The Banks – Phase 3C  
Public Infrastructure Development  
Bid Package #2 – Lot 28 Park & Garage  
January 21, 2022  
THP #98090.40

## **ADDENDUM #4**

A202

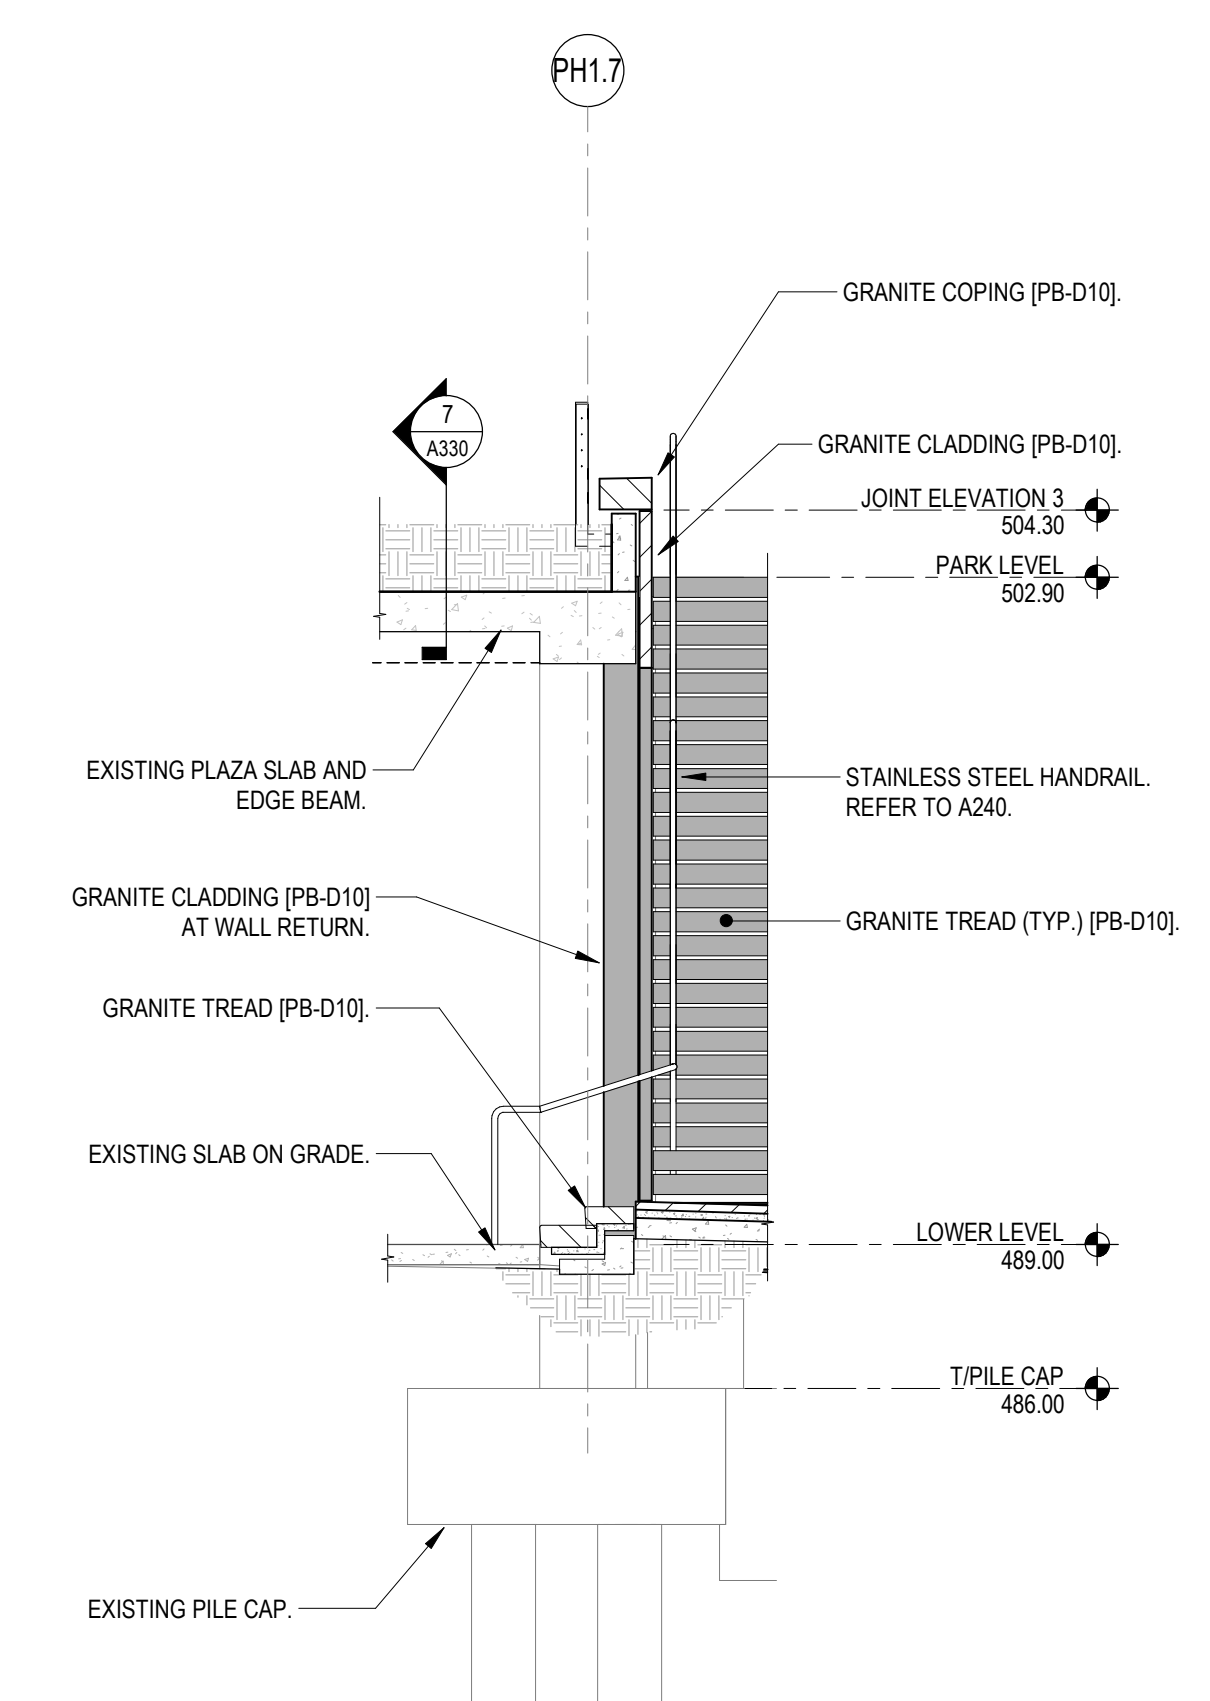
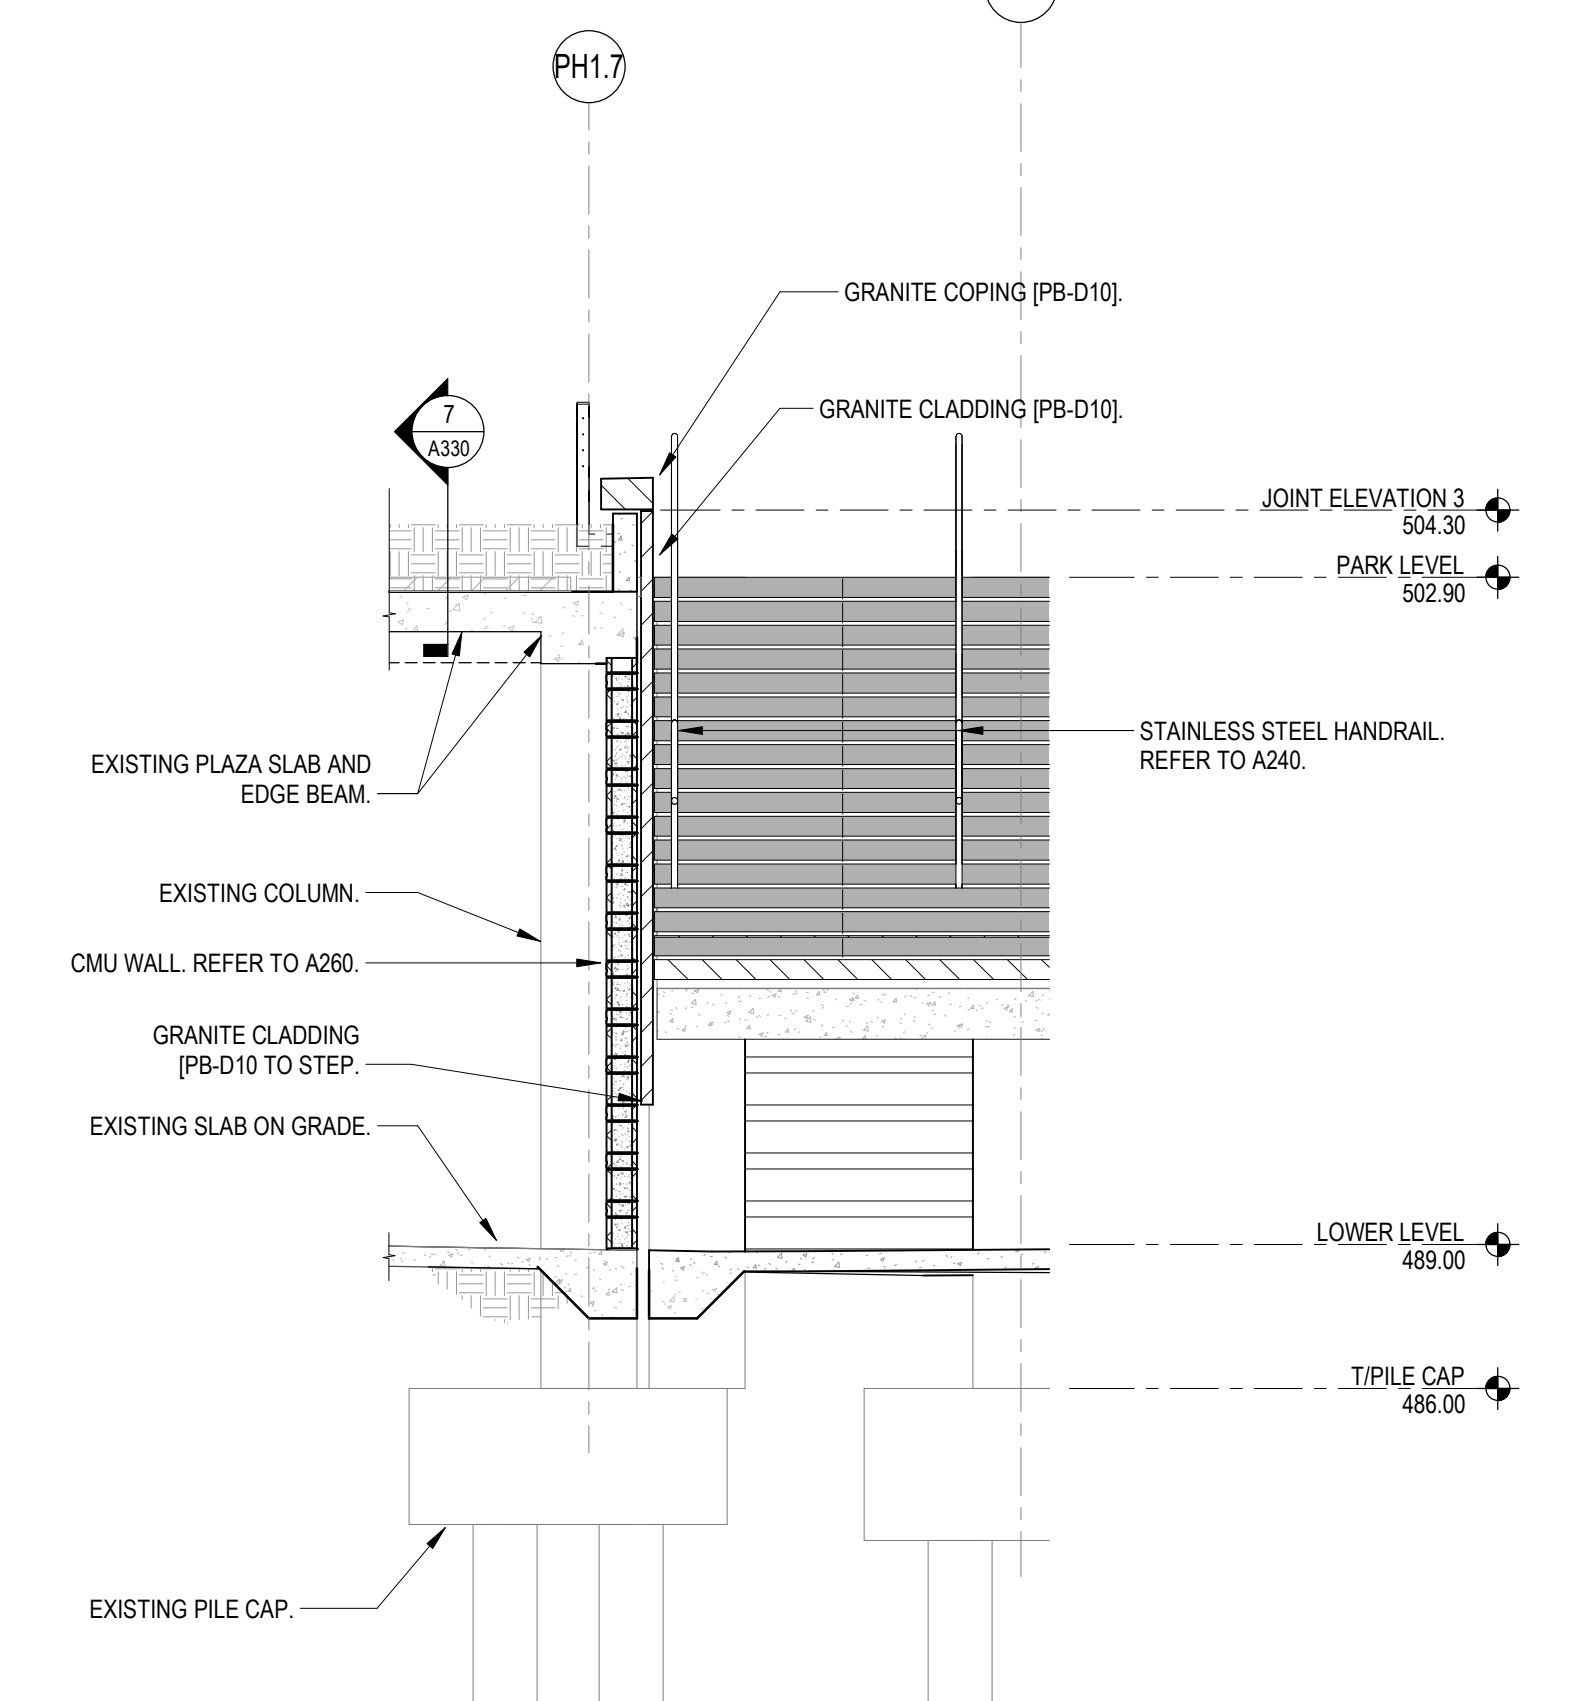
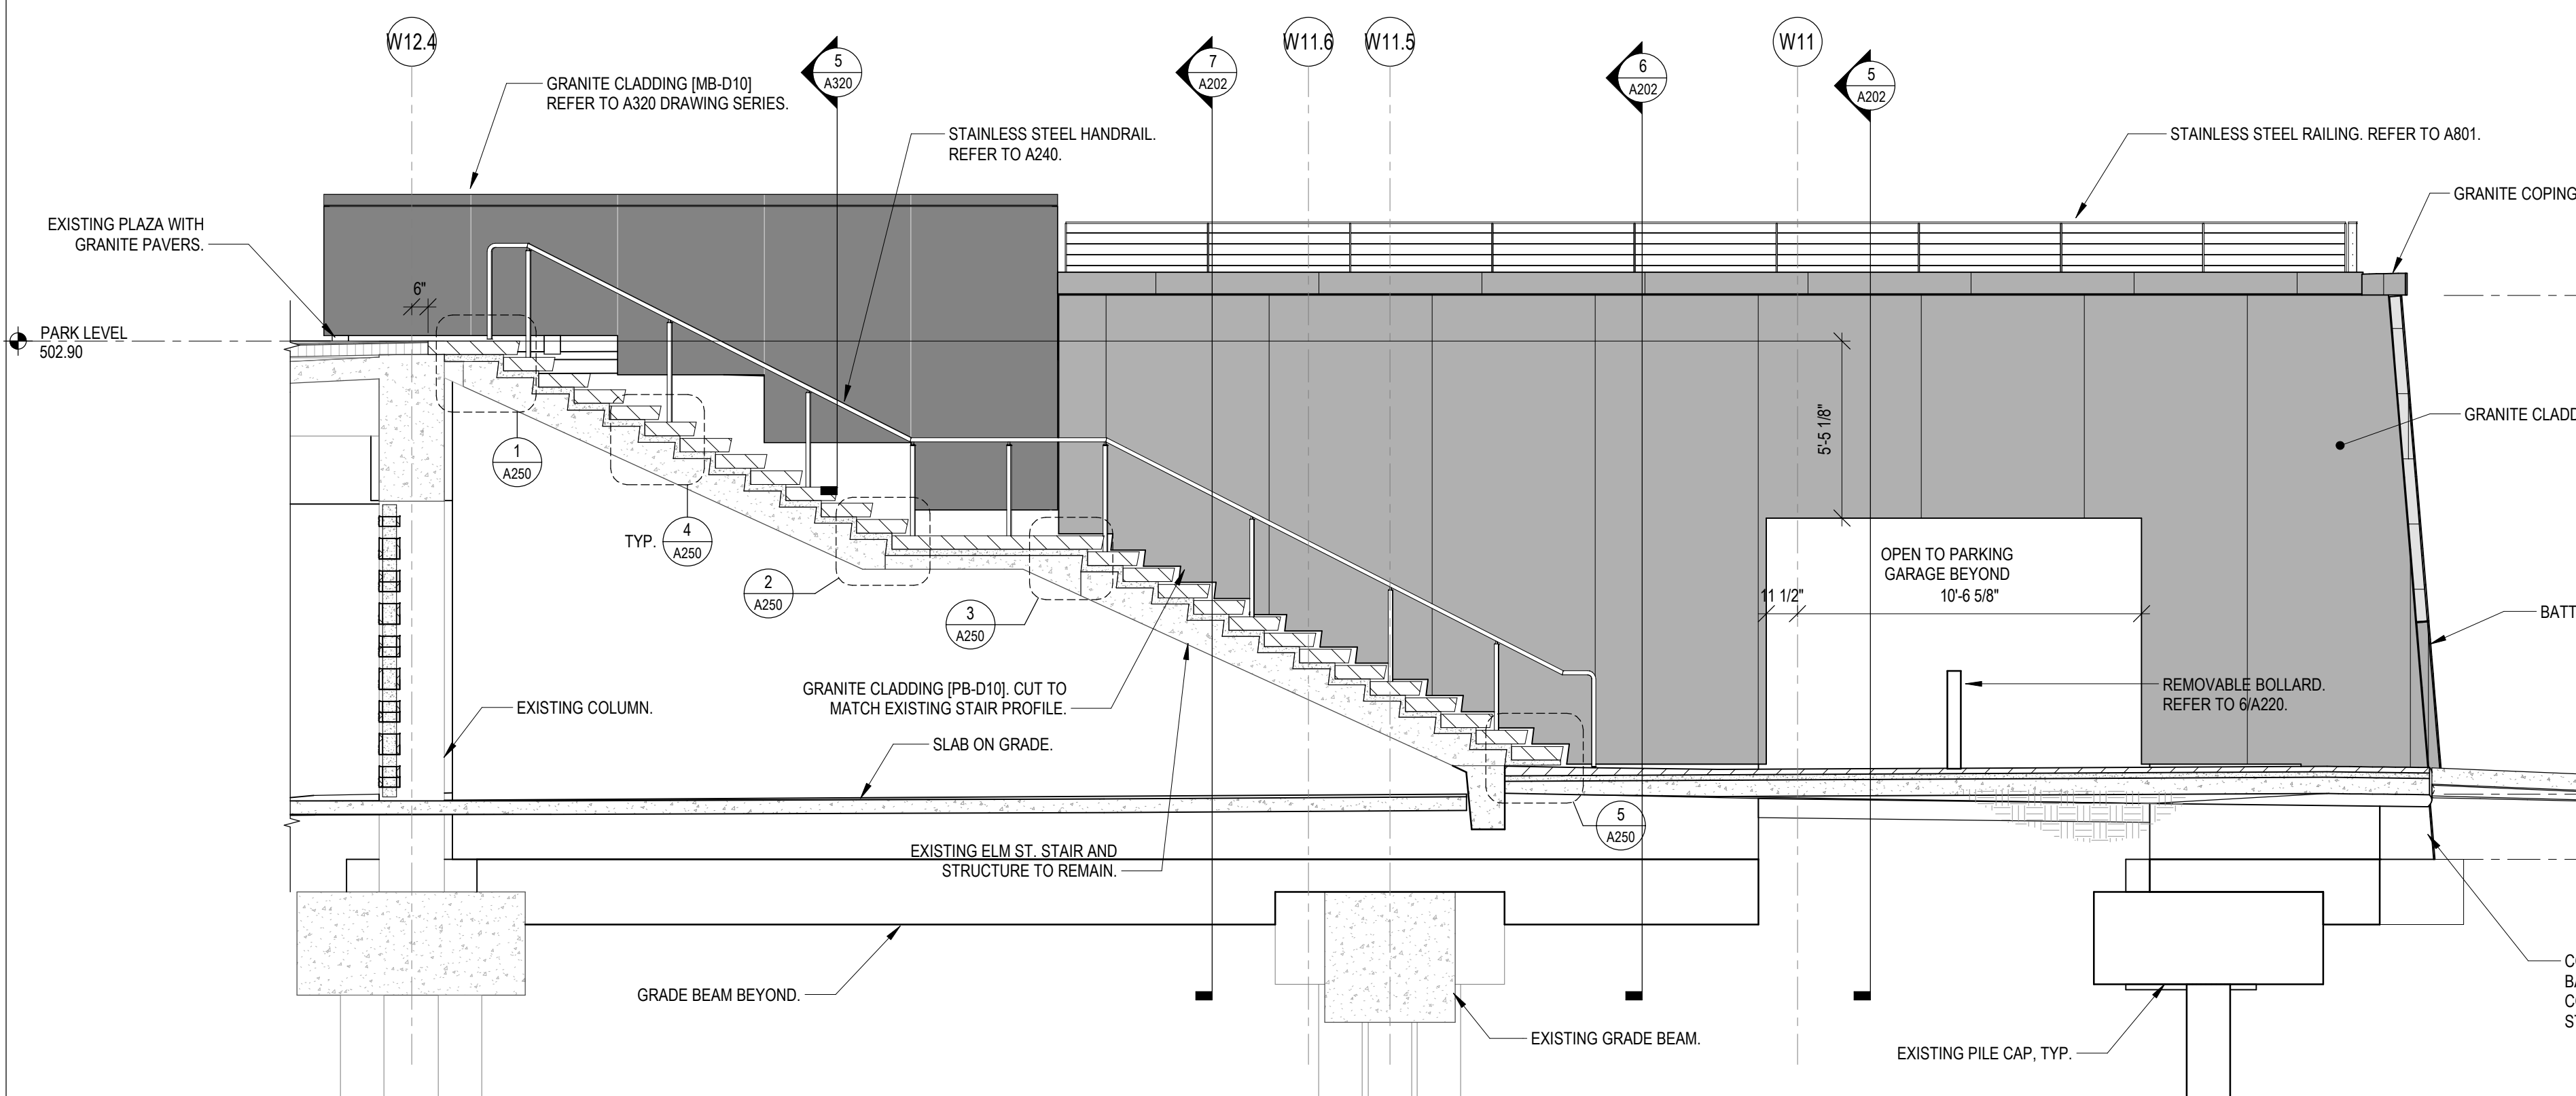
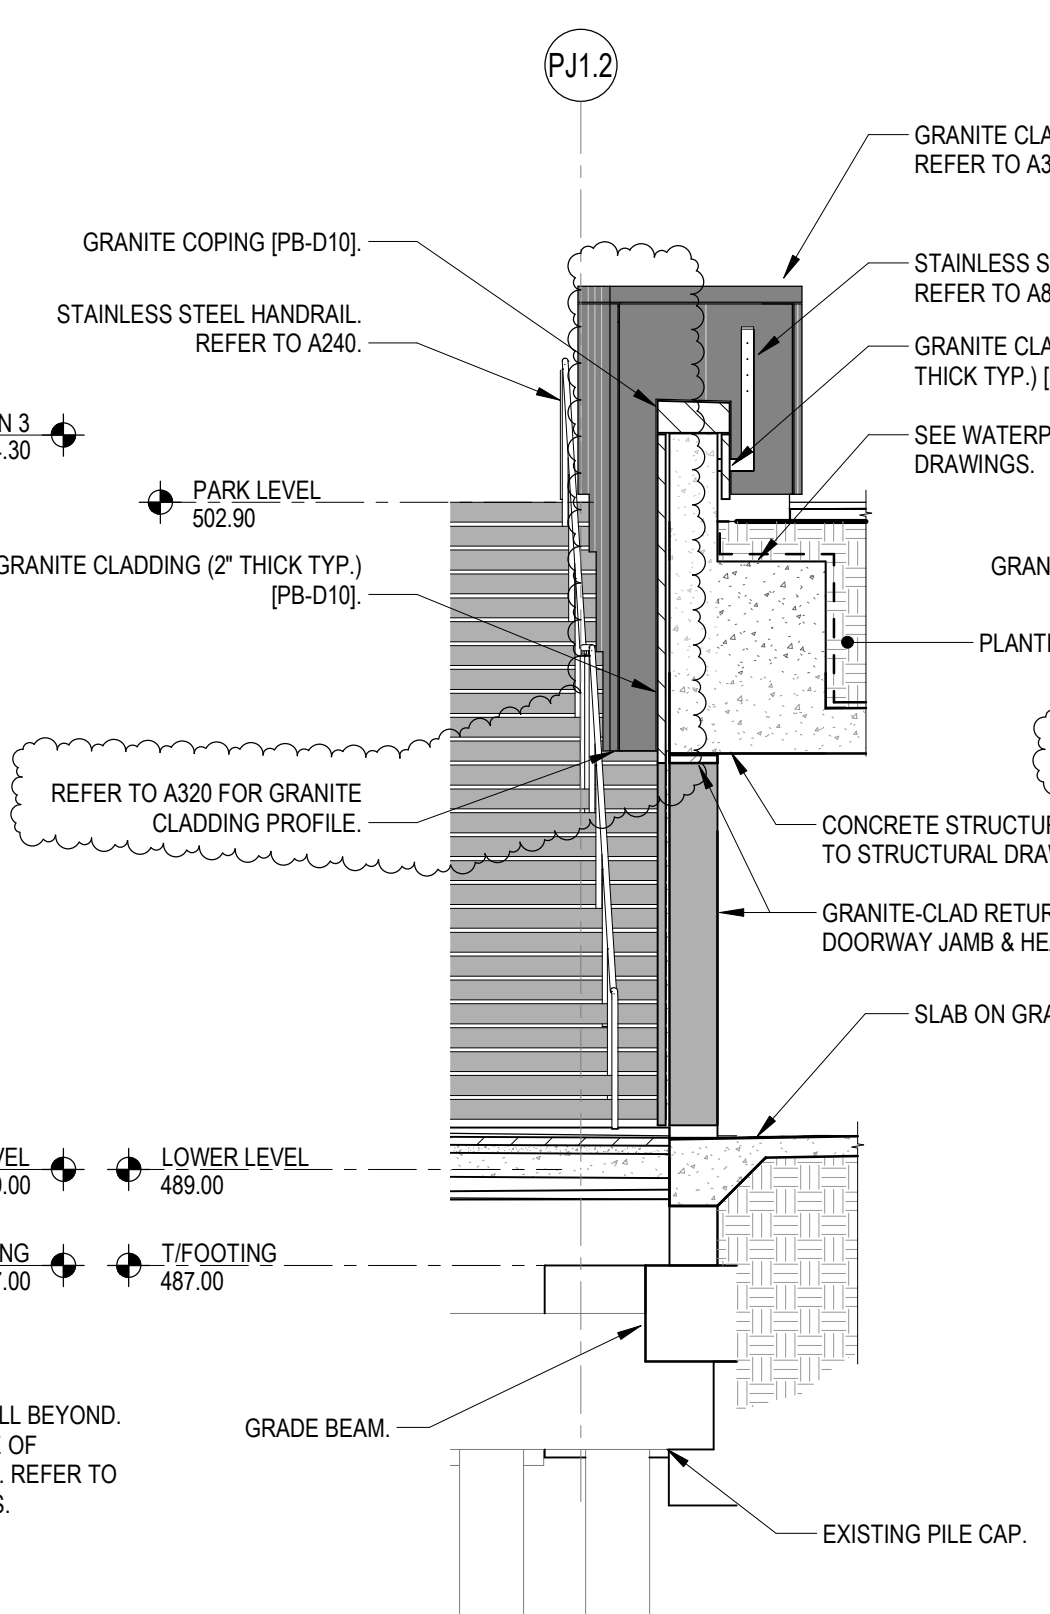
1. **Drawing A202:** (Sheet Reissued)
  - Extents of west granite cladding at the Elm St. Stair entry marker have been adjusted. See revision clouds.
2. **Drawing A240:** (Sheet Reissued)
  - Delete/disregard detail 3/A240 - refer to A801 for details on the back of concrete wall mounted rail.
  - Railing key plan, detail 5/A240, added for clarity.
  - The title of detail 4/A240 has been updated.
3. **Drawing A801:** (Clarification)
  - Delete/disregard Details 3 & 4/A801 – there are no longer any glass railings in BP #2.
4. **Drawing S201:** (Sheet Reissued)
  - Revise Section 11/S201 to accommodate seating bench along Mehring Way sidewalk.
